Detailed Site Plan Westridge (Formerly D'Arcy South)

DSP-06079-04

STAFF REPORT

SUBJECT: Detailed Site Plan DSP-06079-04
Type II Tree Conservation Plan TCPII-034-098-04
Westridge (Formerly D'Arcy South)

SITE PLAN

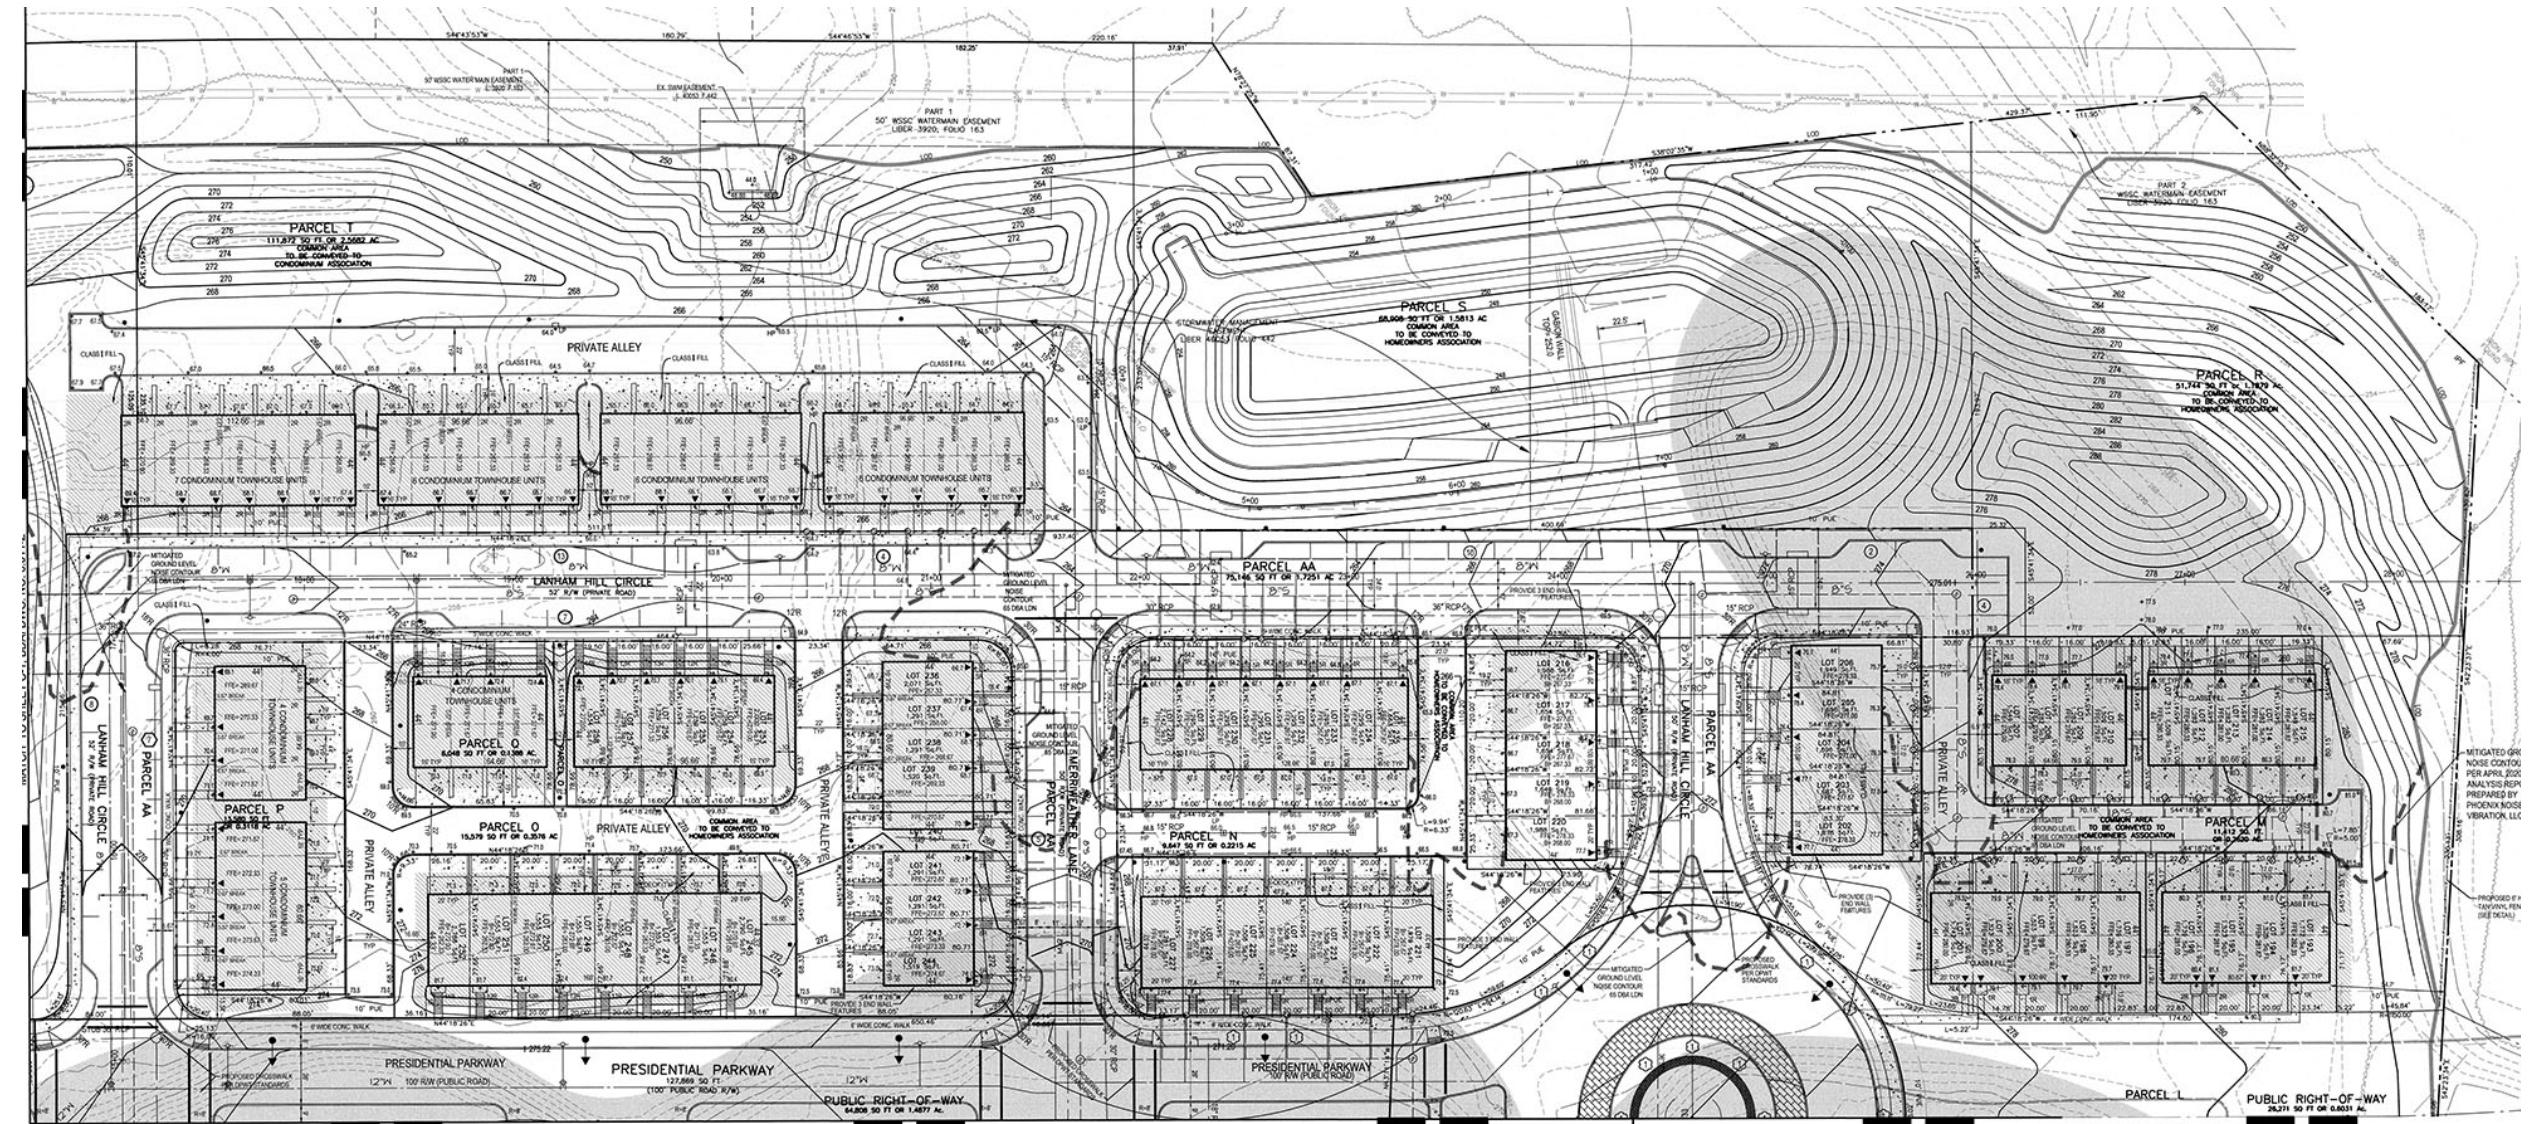
In addition, the Phase II noise analysis concludes that outdoor activity areas, including all rear yards of dwelling units, will be below the exterior limit of 65 dBA Ldn, but the mitigated ground-level noise contours shown on the plan do not support this conclusion. In order to protect the long-term health and welfare of the residents whom may be using their rear yards, including driveways, for various activities, the plan should be revised such that the 65 dBA Ldn does not impact any rear yards. Therefore, a condition is included herein requiring the plans and noise study to address this issue, which may require the need for the addition of a noise barrier, additional berming and planting, or other mitigation measures.

A Phase II noise study was submitted with this application, and concludes that all outdoor activity areas are outside of the 65 dBA Ldn contour line. However, the plan and exhibits do not reflect this as true. Therefore, a condition is included herein requiring all interior noise levels be mitigated to 45 dBA Ldn or less, consistent with the condition included in the PPS.

- g. Revise the plans and Phase II noise study, as needed, to ensure all outdoor activity areas, including all rear yards of dwelling units, will be below 65 dBA Ldn. This may require the need for the addition of a noise barrier or other mitigation measures.

Five-Foot Wide Sidewalk

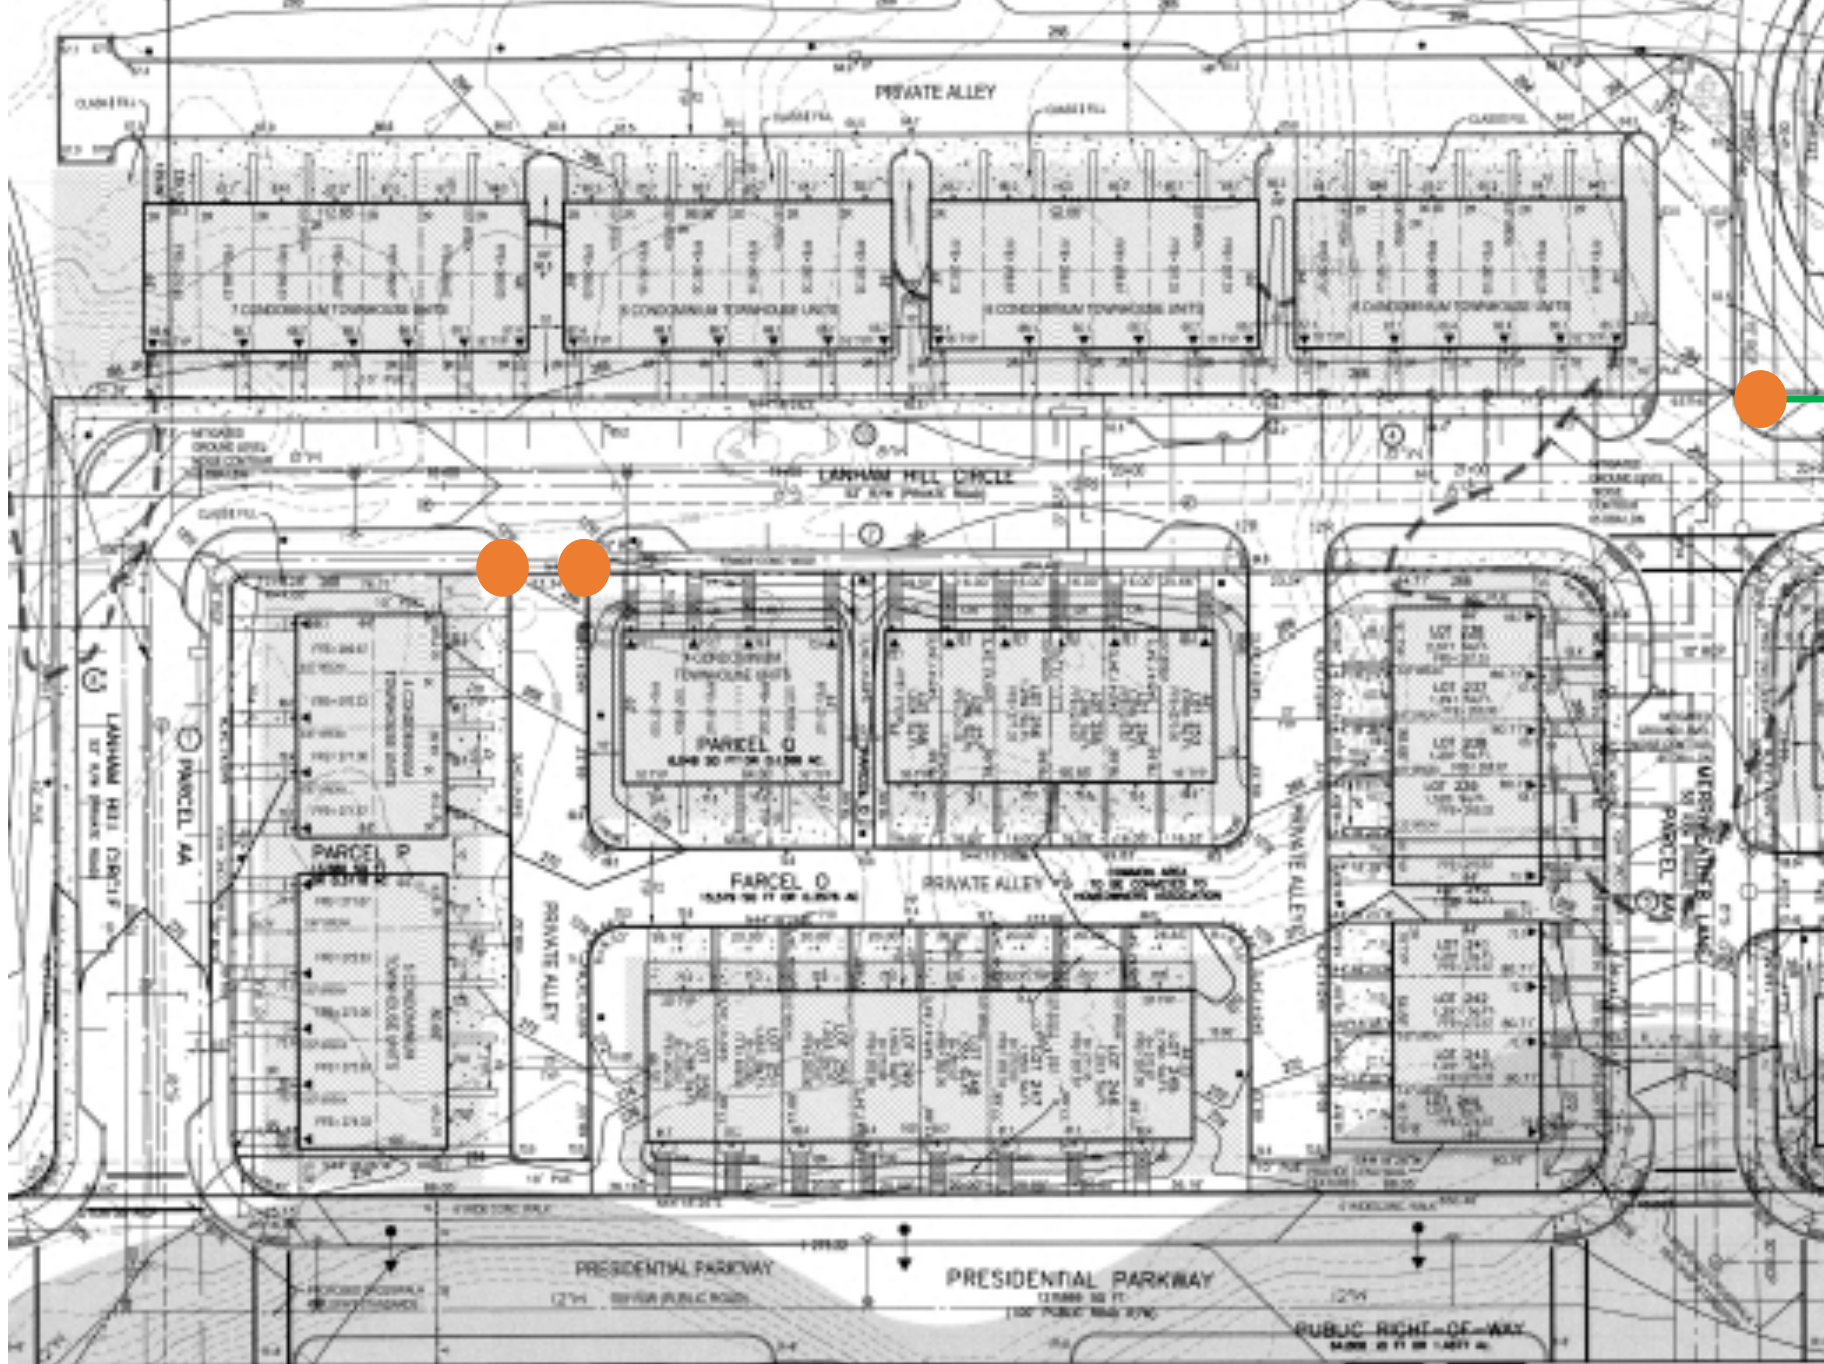
1a. Provide minimum 5-foot-wide sidewalks along both sides of the full extent of Lanham Hill Circle, on internal roads, and all lead walks, to meet Americans with Disability Act standards.

MATCH TO SHEET C-5, BDAI DWG. NO. 6:015-Z

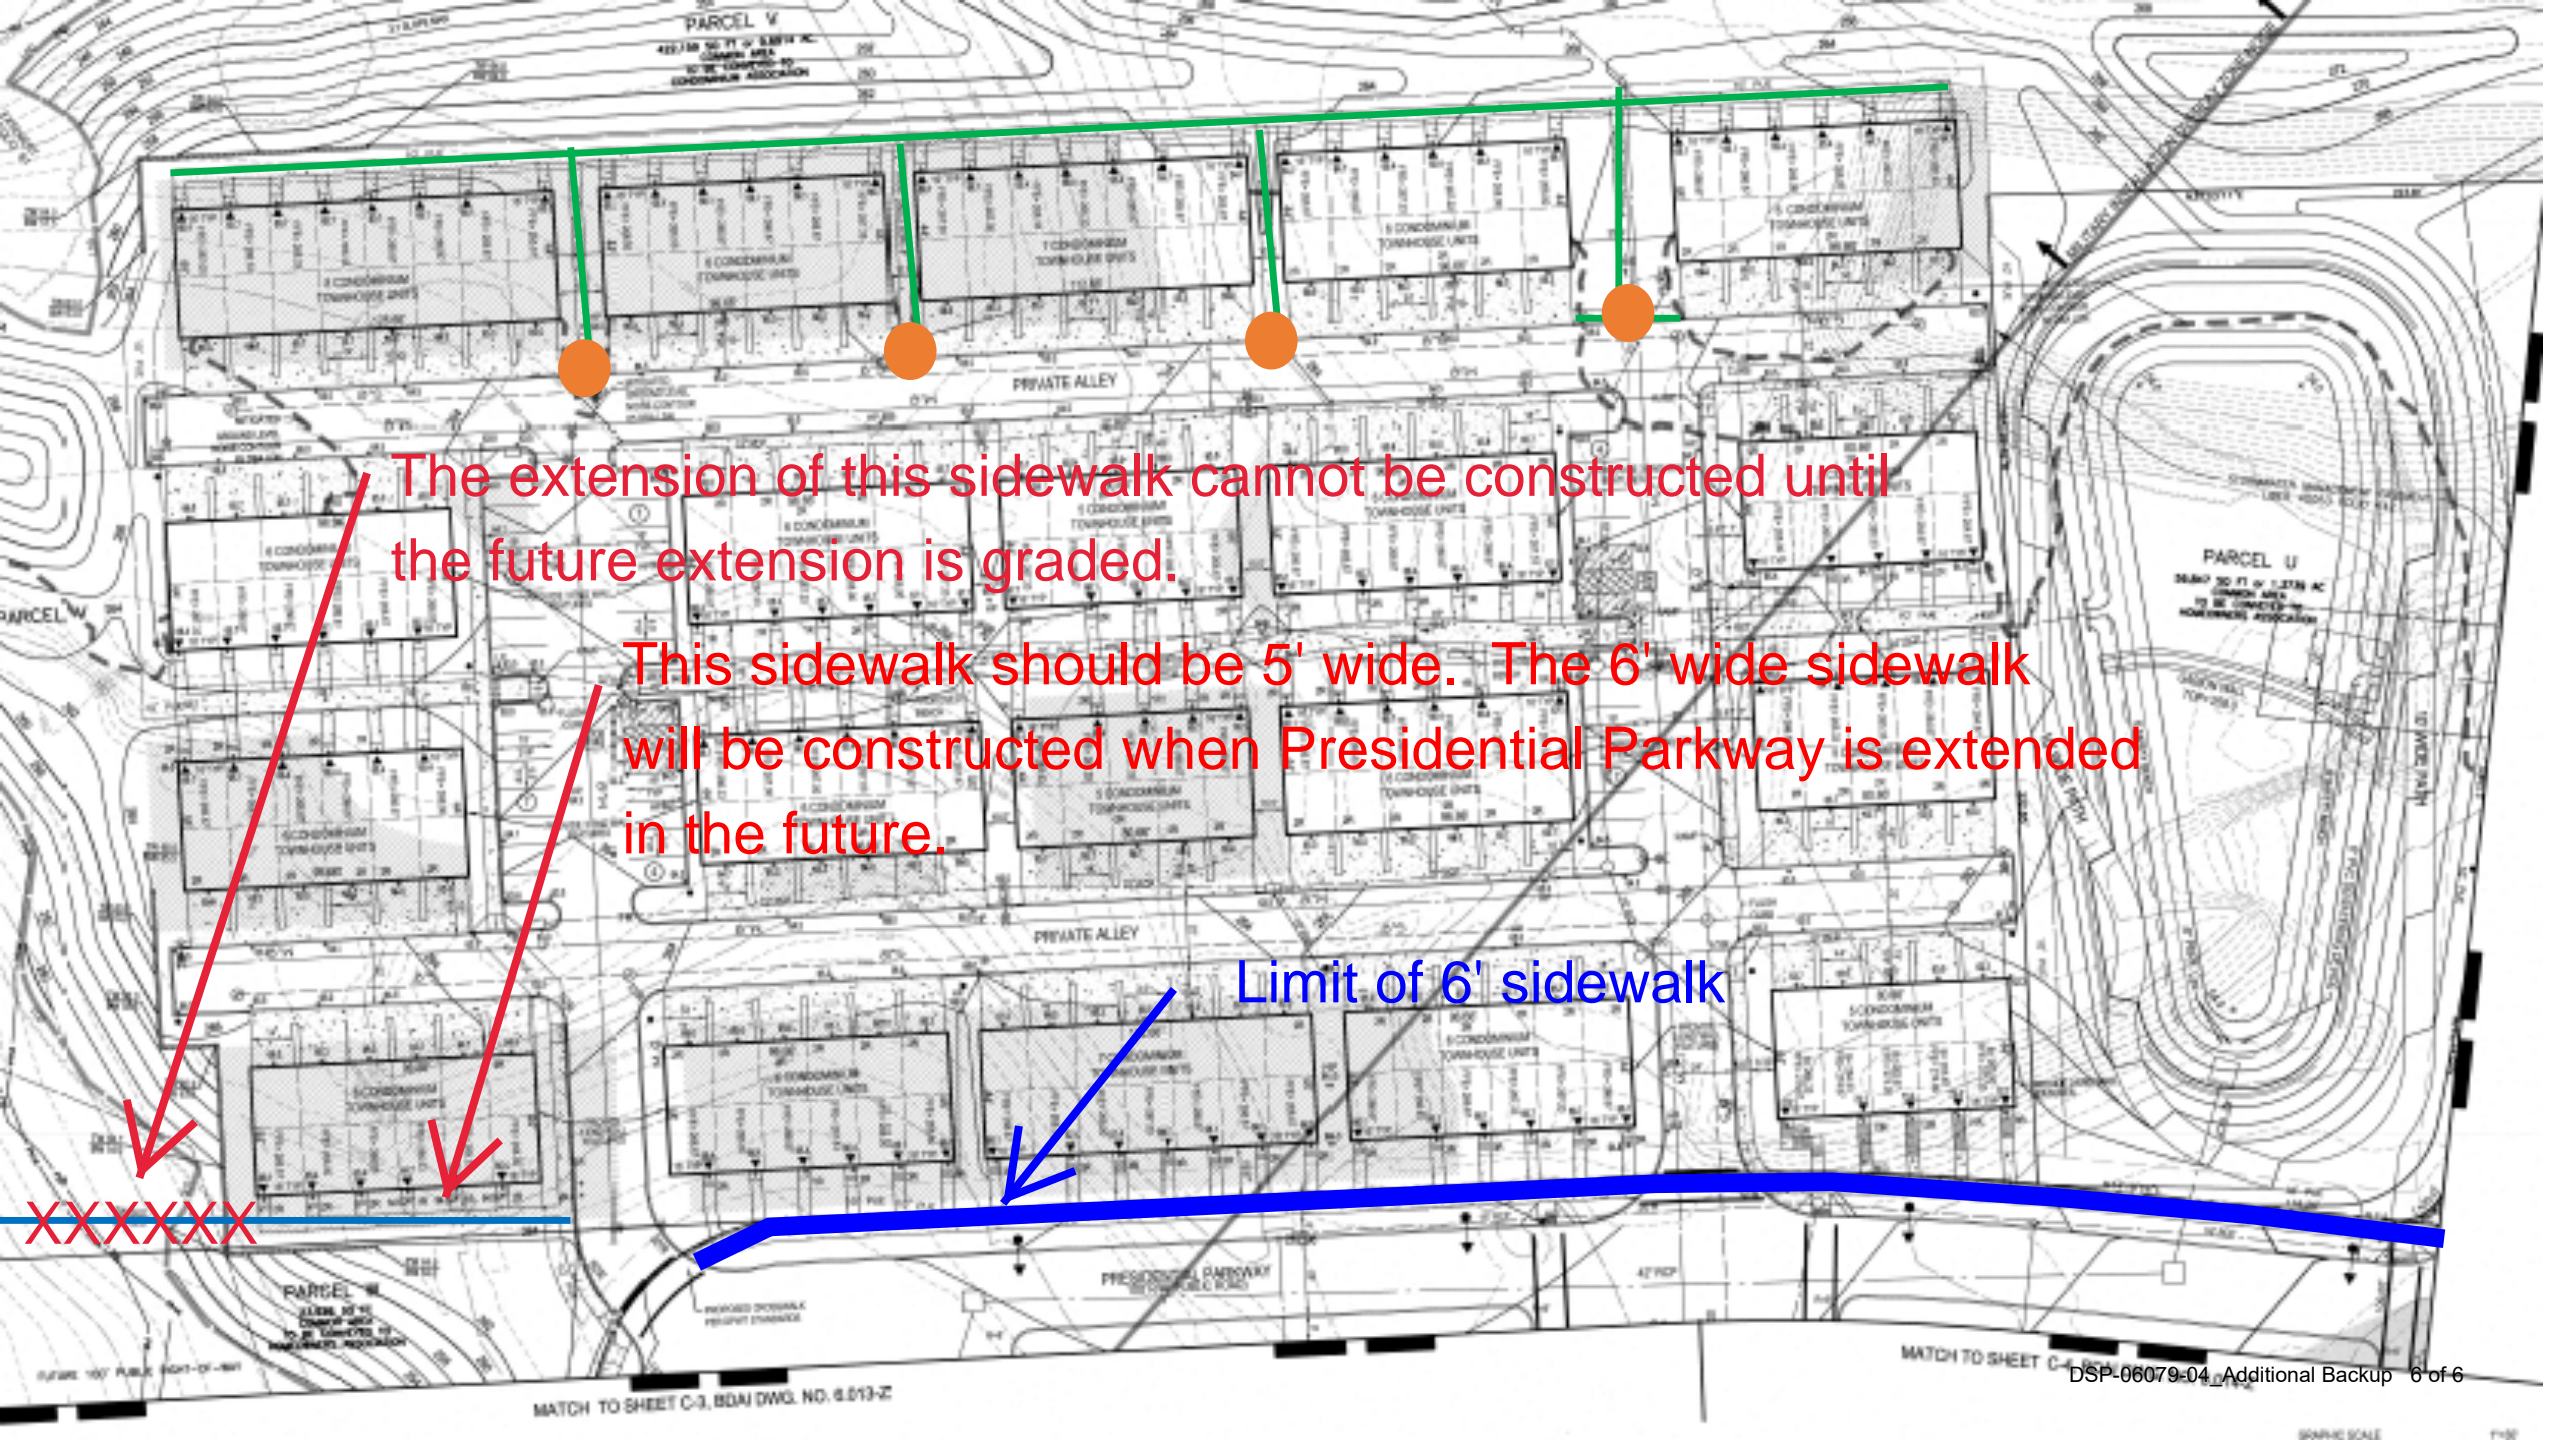
The extension of this sidewalk cannot be constructed until the future extension is graded.
